# DEVELOPMENT REVIEW BOARD REPORT

32-DR-2005 CASE NUMBER/

**80<sup>th</sup> Street Hangars PROJECT NAME**

Request approval of a site plan and elevations for two office buildings and an REQUEST

LANDSCAPE PLAN

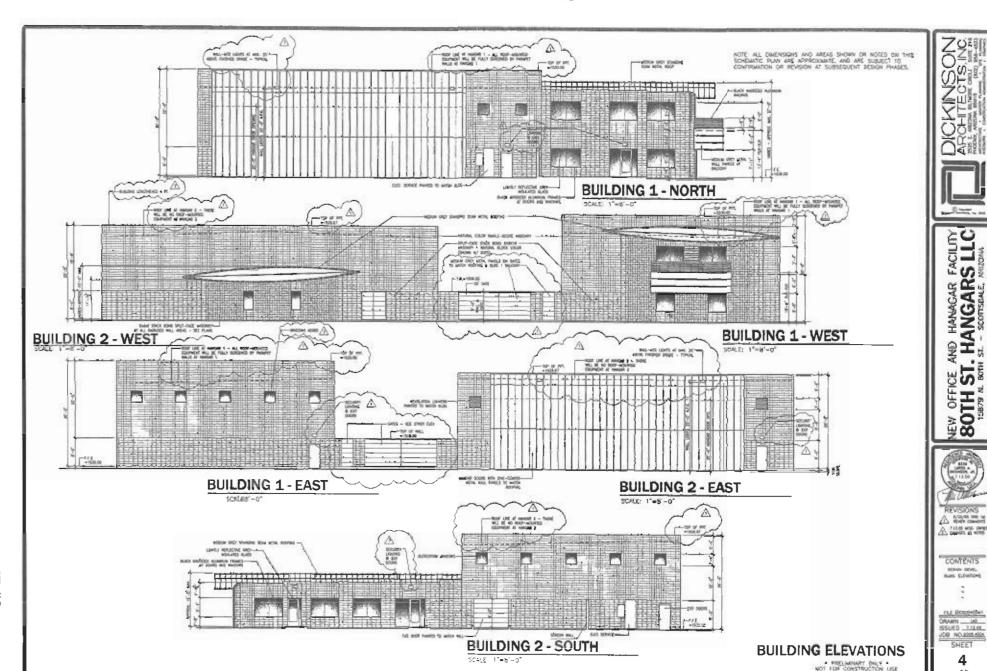
- 11. Cut and fill slopes shall be rounded to blend with the existing contours of the adjacent natural grades.
- 12. Modify landscape plan replacing some of the lantana located south of the drive aisle with some shrubs, to the satisfaction of final plans staff.
